October 25, 2018

**SUBJECT: Permit Update – Response to Comments
Hanson Aggregates Pennsylvania LLC – Rock Hill Quarry
SMP No. 7974SM1
East Rockhill Township, Bucks County, PA
EarthRes Project No.: 061003.052**

Response to September 6, 2018 comments:

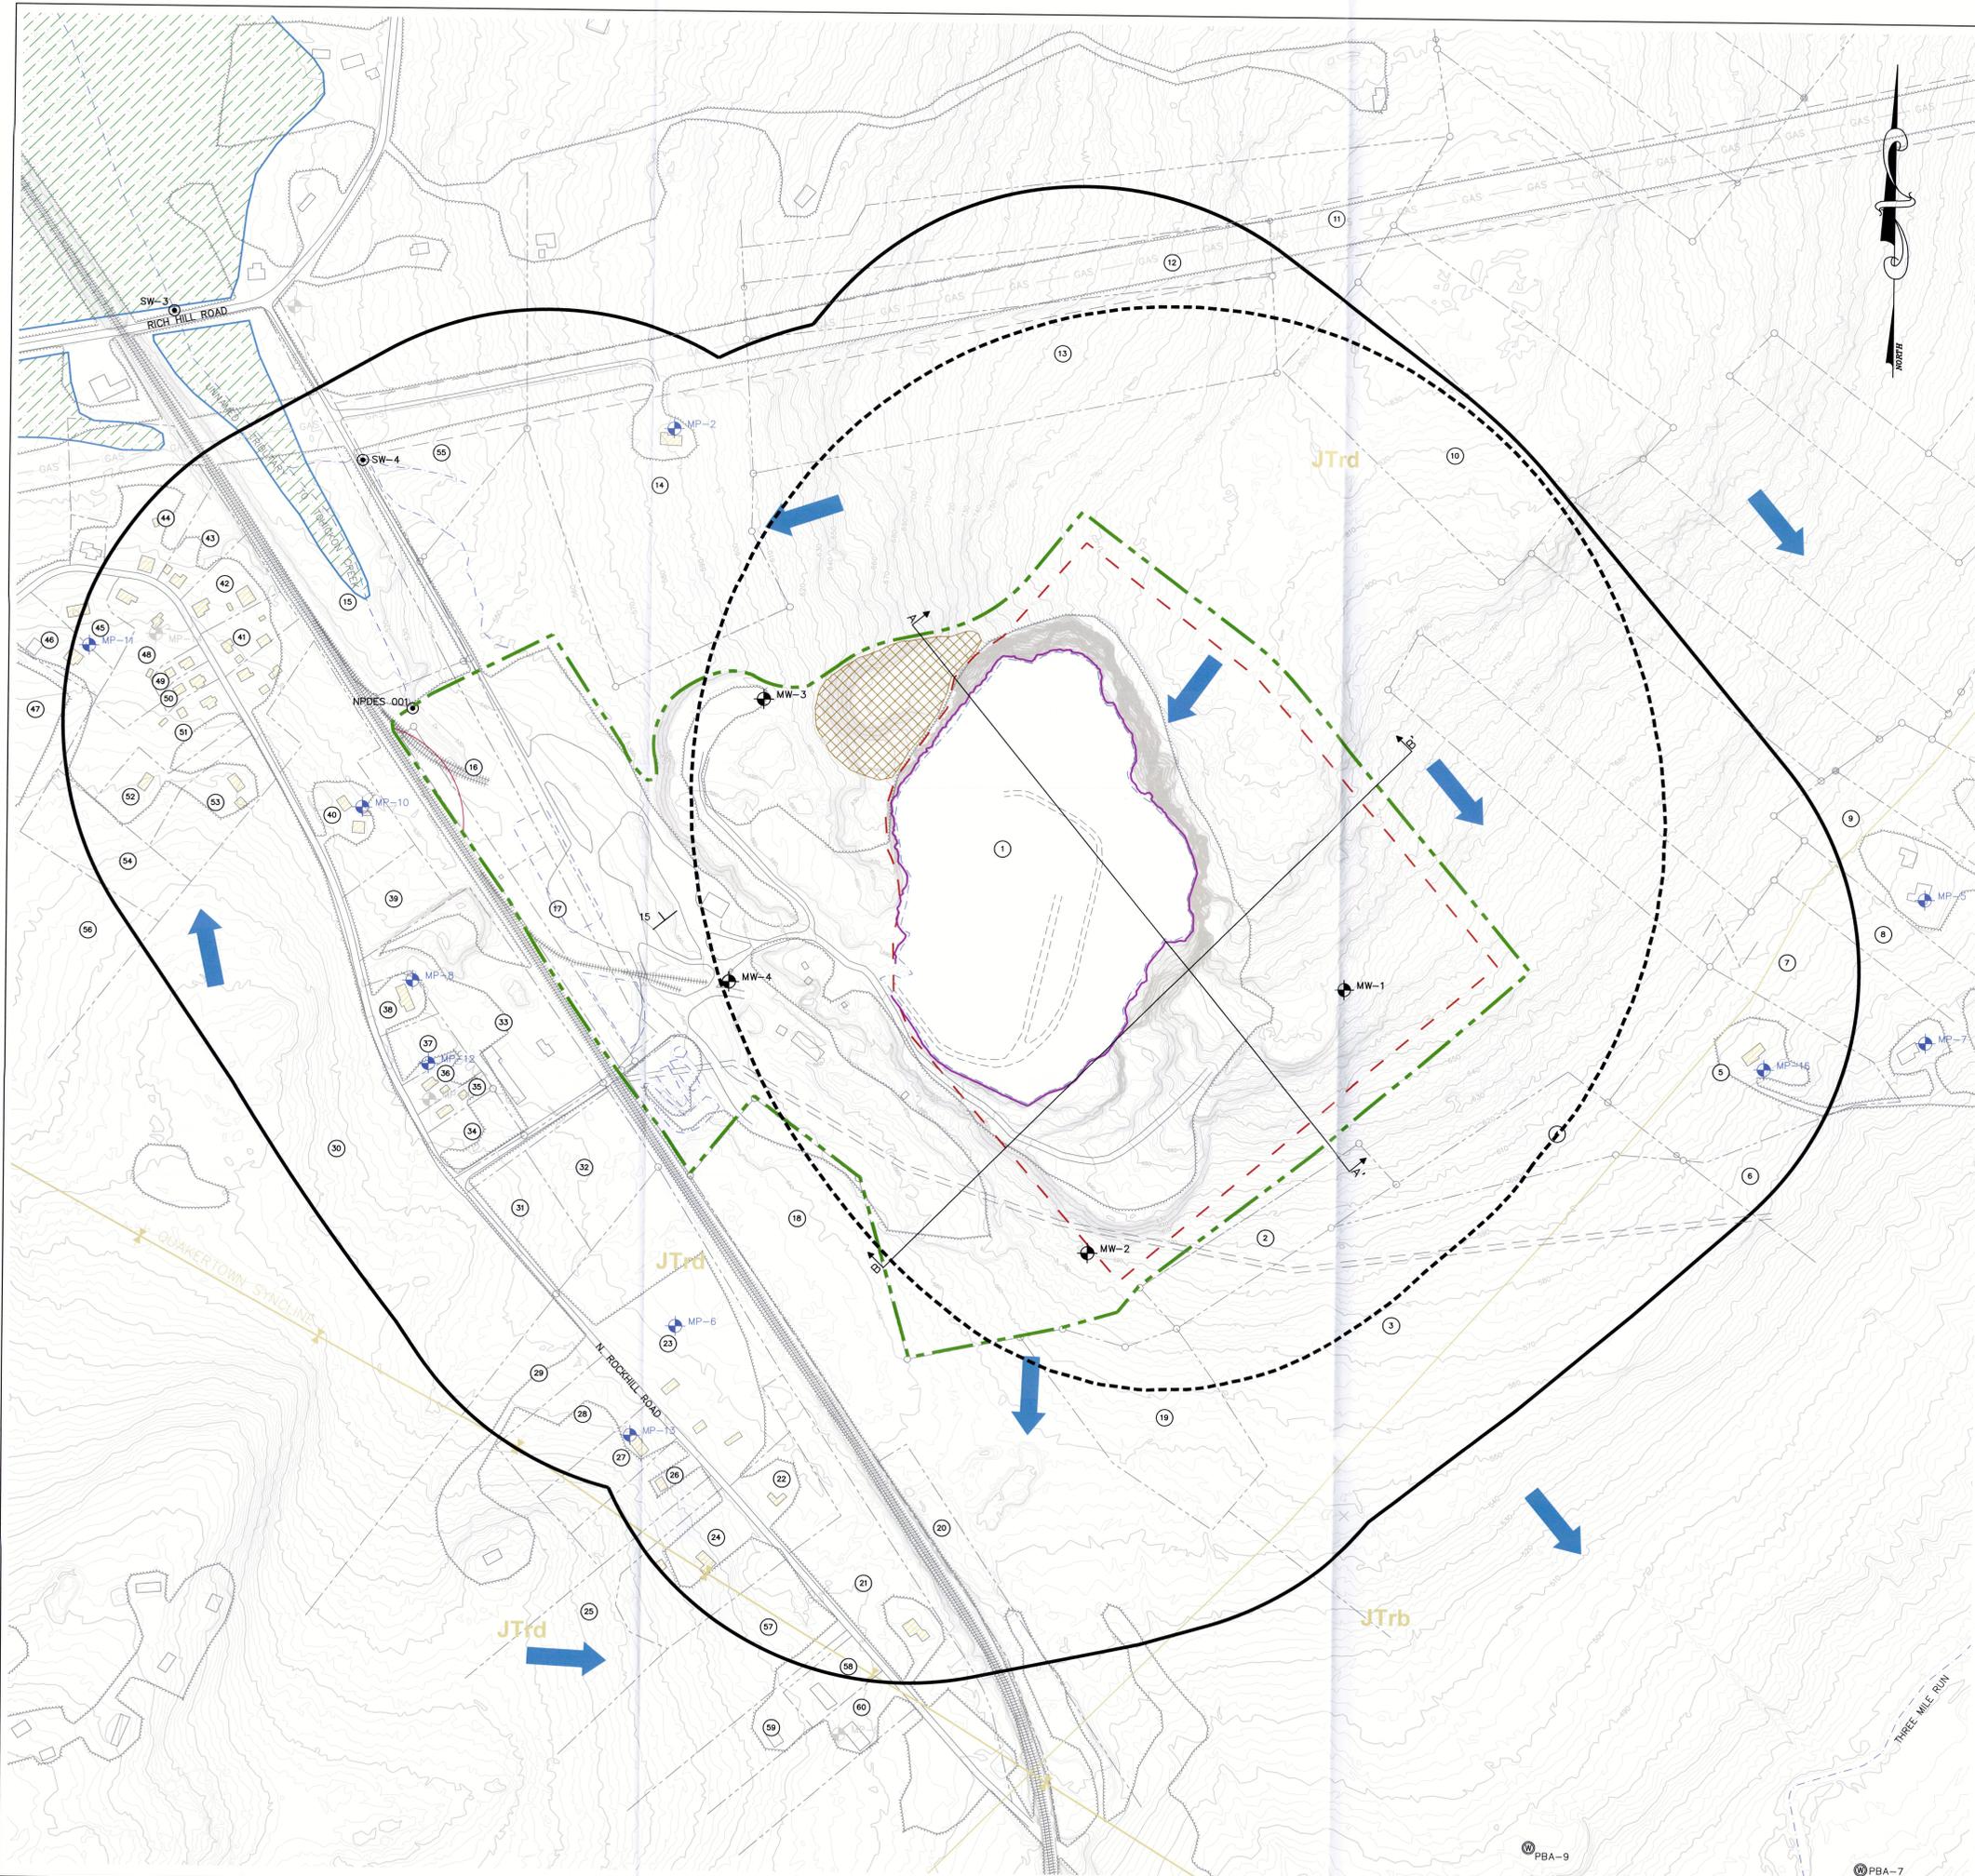
a. Please show background monitoring points SW-1 and SW-2 and provide permit and limit of mining acreages.

b. Please delineate the zone of influence as indicated in 8.6b. See Item 3. e. (77.410)

Response: SW-1 and SW-2 are shown on the inset map included on Exhibit 6.2. The permit and limit of mining acreages have been added to the map.

Response: Exhibit 6.2 has been updated to depict the projected zone of influence.

Module 9
Operations Map

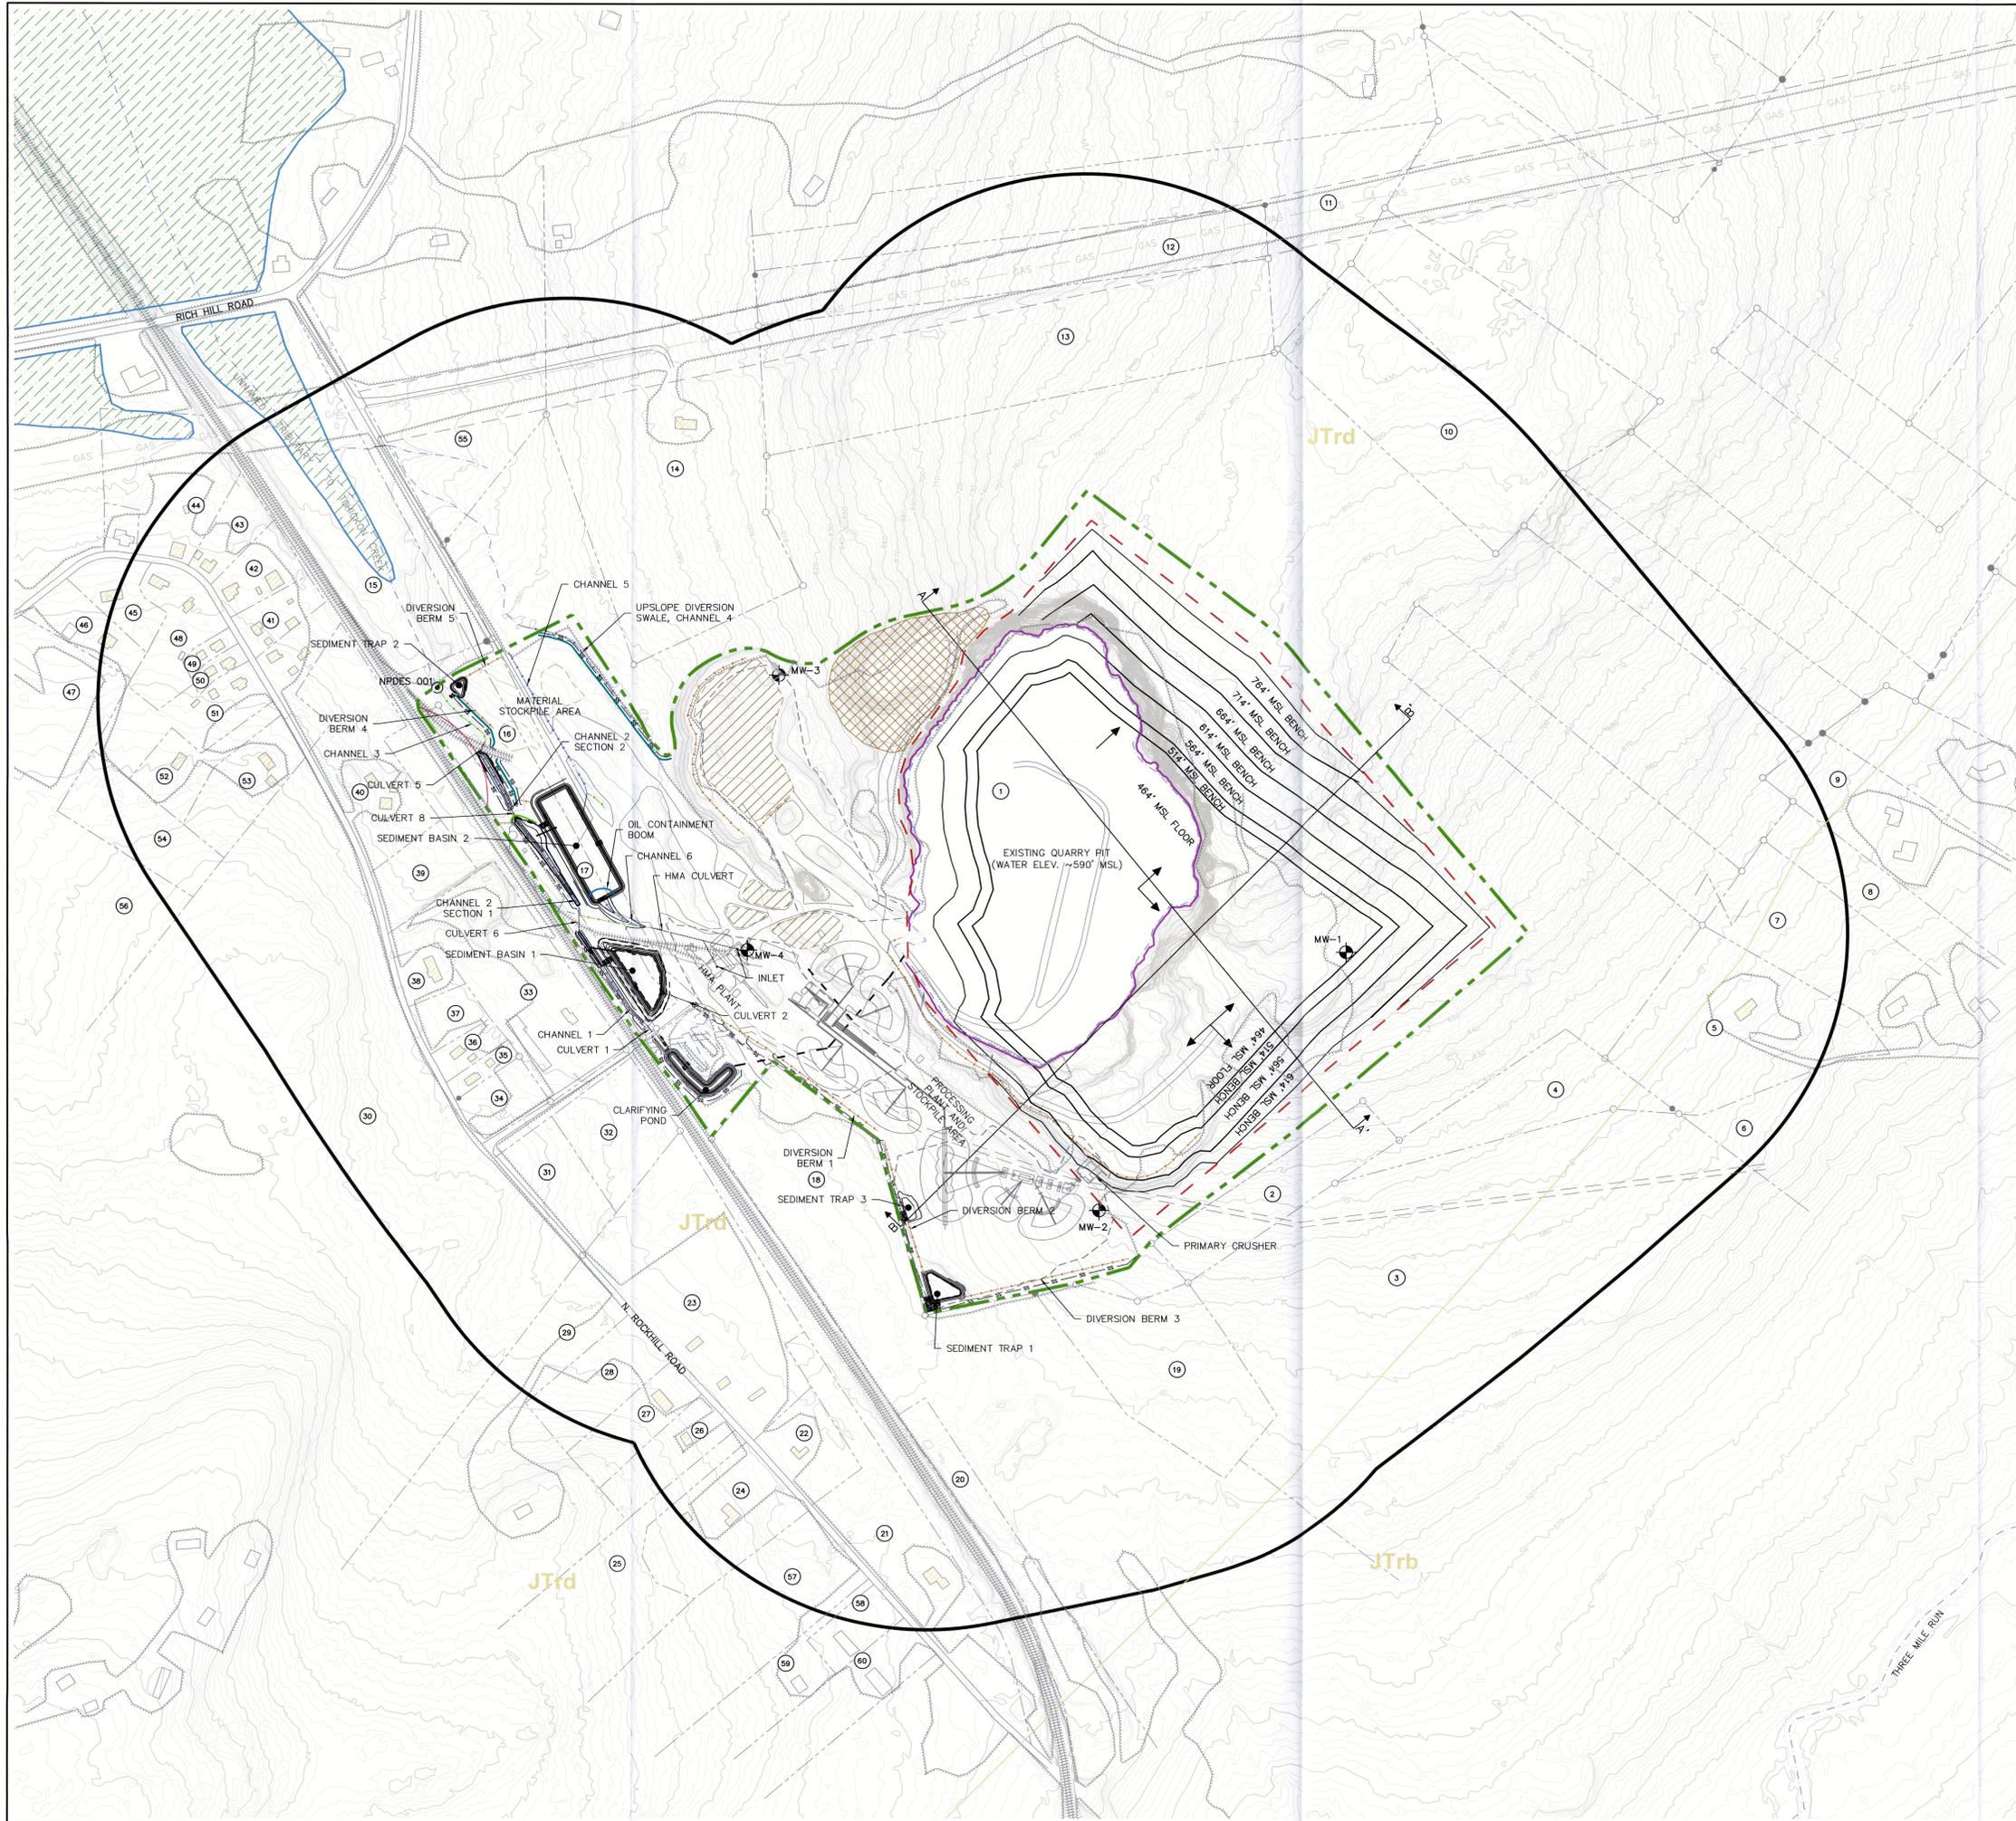
1. *Please provide an updated Module 9: Operations Map [§77.454]*
 - a. *With updates to but not limited to:*
 - i. *Module 9f) – Changes to or locations of new man-made features.*
 - ii. *Module 9n) – Changes to or new water treatment facilities specifically the Oil/Water Separator*
 - iii. *Module 9o) – Changes to or new surface water diversions from the rock processing or asphalt plant areas*
 - iv. *Module 9p) – Changes to or locations of new erosion and sedimentation facilities*
 - v. *Module 9v) – Changes to or locations of new processing facilities and stockpile areas*
 1. *Show RAP storage areas and Volumes*
 - vi. *Module 9w) – Changes to or locations of new air pollution or sound pollution control facilities*

Response: Exhibit 9 has been updated to show proposed locations of the Processing Plant, Hot Mix Asphalt Plant and associated stockpile areas, E&S control devices and treatment facilities.

Drainage Area Map

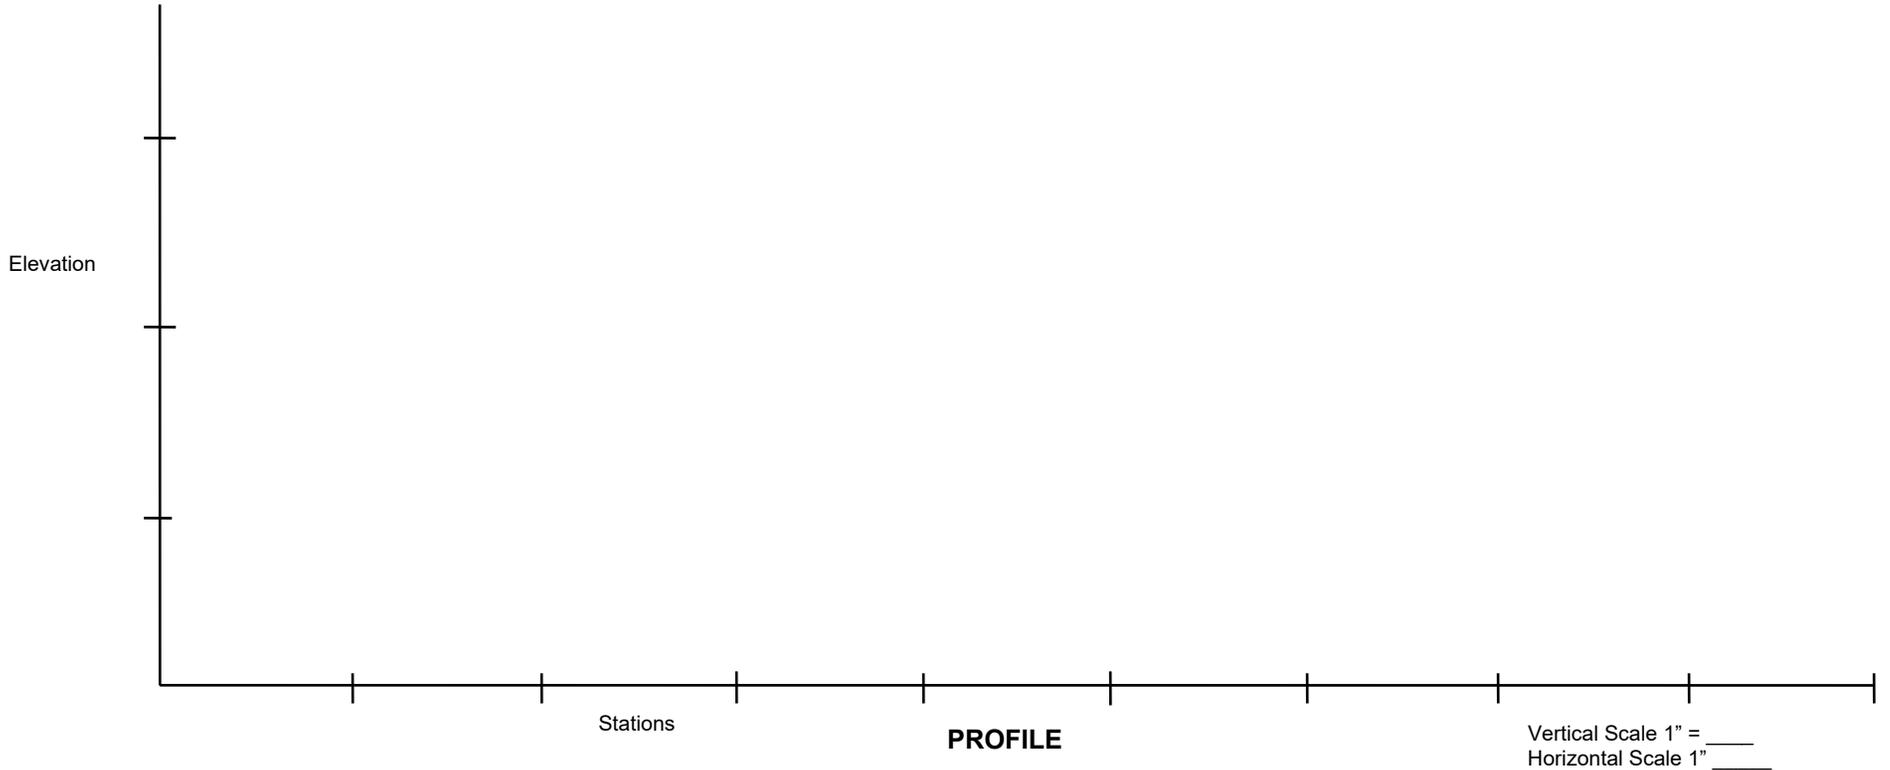
3. *Please provide an updated Module 12: Erosion and Sediment Control Plan [§77.458/77.461/77.466/77.525/77.527/77.531/Chapter 102]*
 - a. *With updates to but not limited to:*
 - i. *12.2 Erosion and Sediment Control of runoff from the rock processing and asphalt plant areas*
 1. *Berms*
 2. *Sedimentation Traps*
 3. *RAP storage areas*

In addition, a revised copy of the drainage area map has been provided to include the updated topographical information for the proposed Processing Plant and Asphalt Plant Area and to include revisions to the stormwater handling plan for these areas. The drainage areas were reviewed to confirm if changes were needed to downstream treatment facilities. Following review, it was determined that the existing controls provide sufficient capacity to manage the change. Updated volume calculations for Sediment Basin 2 are included as an attachment to Module 12.
